South Dakota Public Utilities Commission  
Tatanka Ridge Wind Project, LLC  
Docket EL 19-026  
Response to Staff's Fifth Data Request

Date: October 28, 2019

Figure DR5-3(a)-1  
 Predicted Cumulative Sound Pressure Levels (dBA)  
 NARUC Method  
 Tatanka Ridge Wind Project

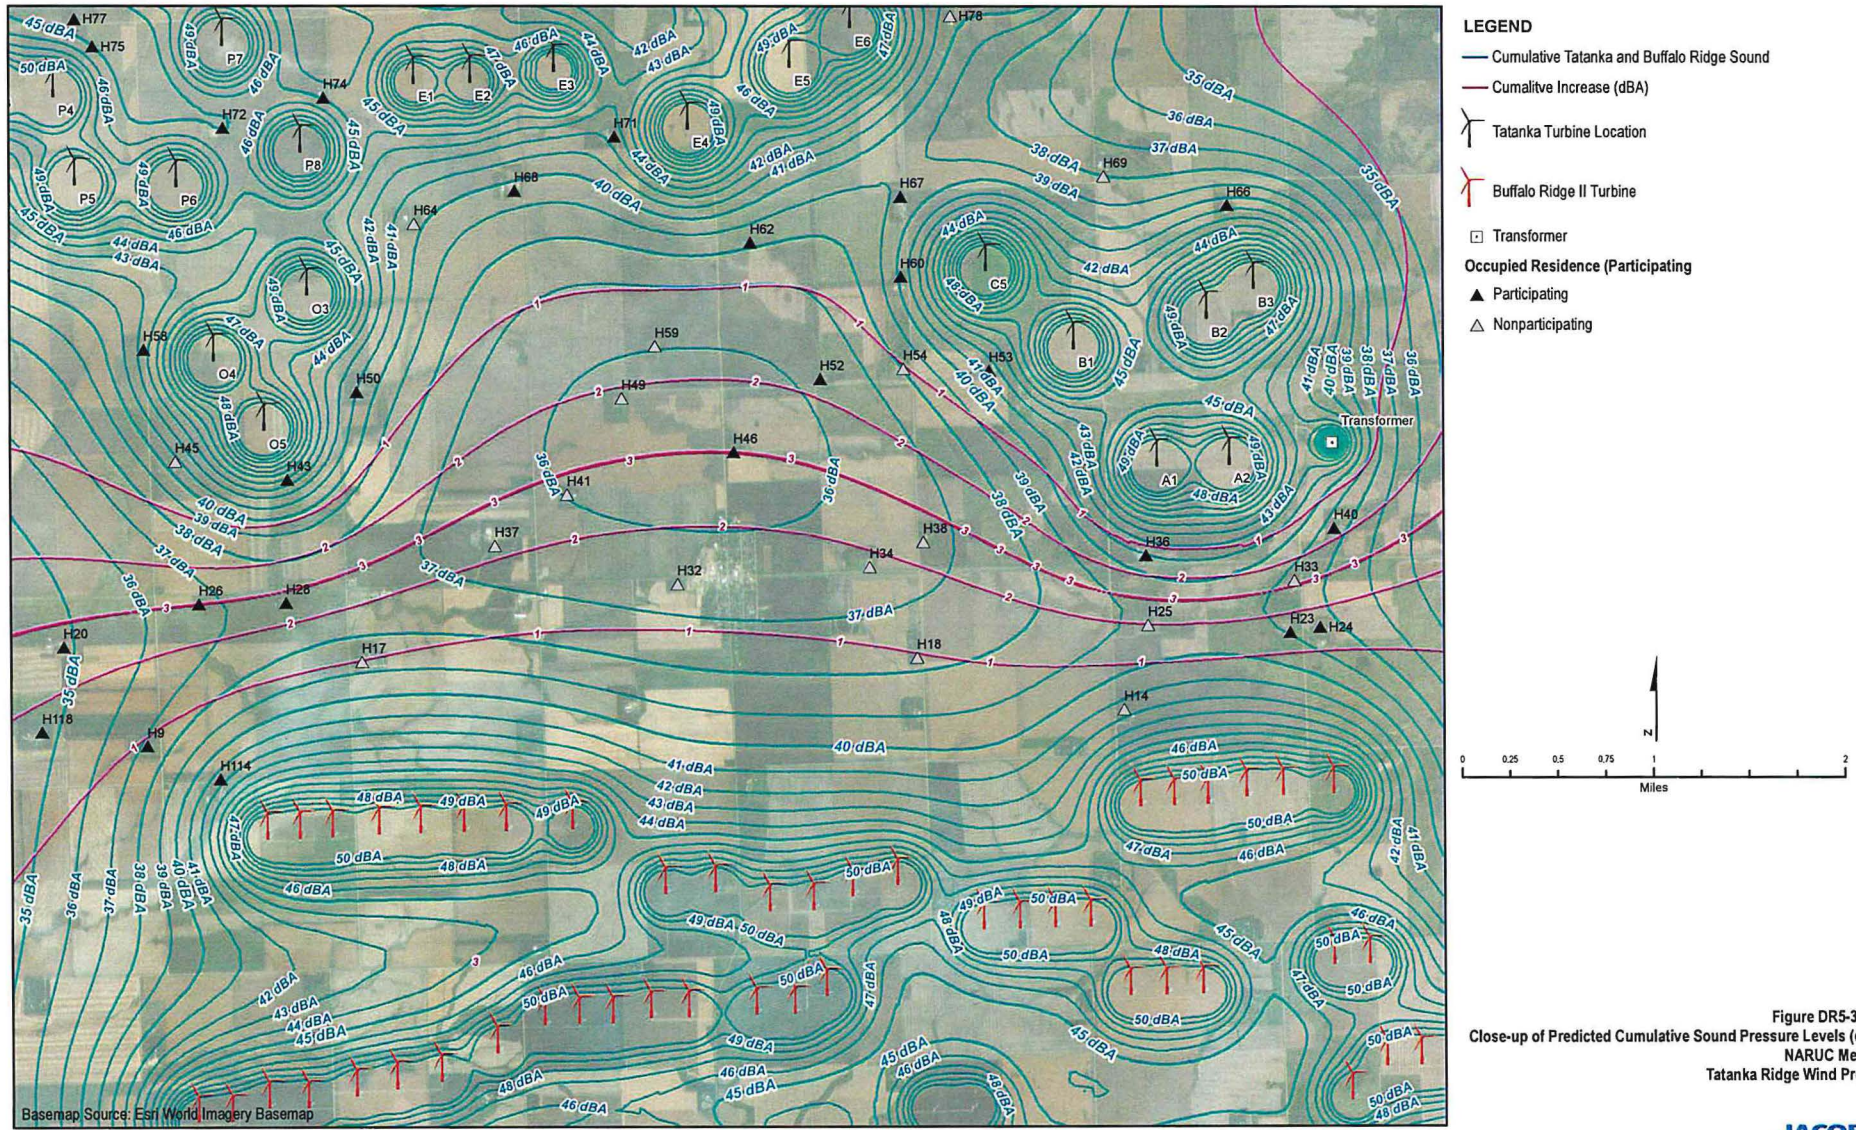
- a) How should cumulative impacts from adjacent wind facilities, such as Buffalo Ridge II, be considered when analyzing sound compliance with regulatory limits?

- d) Refer to the Applicant's response to Staff Data Request 2-33.
    - i. For Receptors H14 and H17, are the turbines associated with Buffalo Ridge II the primary source of sound when looking at the cumulative sound level for these residences?

Figures DR5-3(a)-1 and DR5-3(a)-2 depict the cumulative sound levels resulting from simultaneous downwind operations of Buffalo Ridge II and Tatanka (see response to 5-4 for discussion of downwind modeling methods). Also included on this set of predicted sound level contours is a second set of contours depicting areas where there is a potential increase of 1, 2, or 3 dBA is predicted. The greatest increase (3 dBA) occurs in the areas furthest from both projects, where consequentially, the overall cumulative sound levels are lower. When one is closer to either project, the sound level is dominated by that closer project and the sound attributable to the other project, or increase resulting from it, is low.

- d) i. Yes. The turbines associated with Buffalo Ridge II contribute more sound than those associated with Tatanka.
  - ii. The standard applicable to Buffalo Ridge II is 50 dBA. Adjacent may mean to some that the Buffalo Ridge II and Tatanka turbines are in close proximity to each other when they are over 1.5 miles apart. Condition 26 of the Settlement Stipulation appropriately
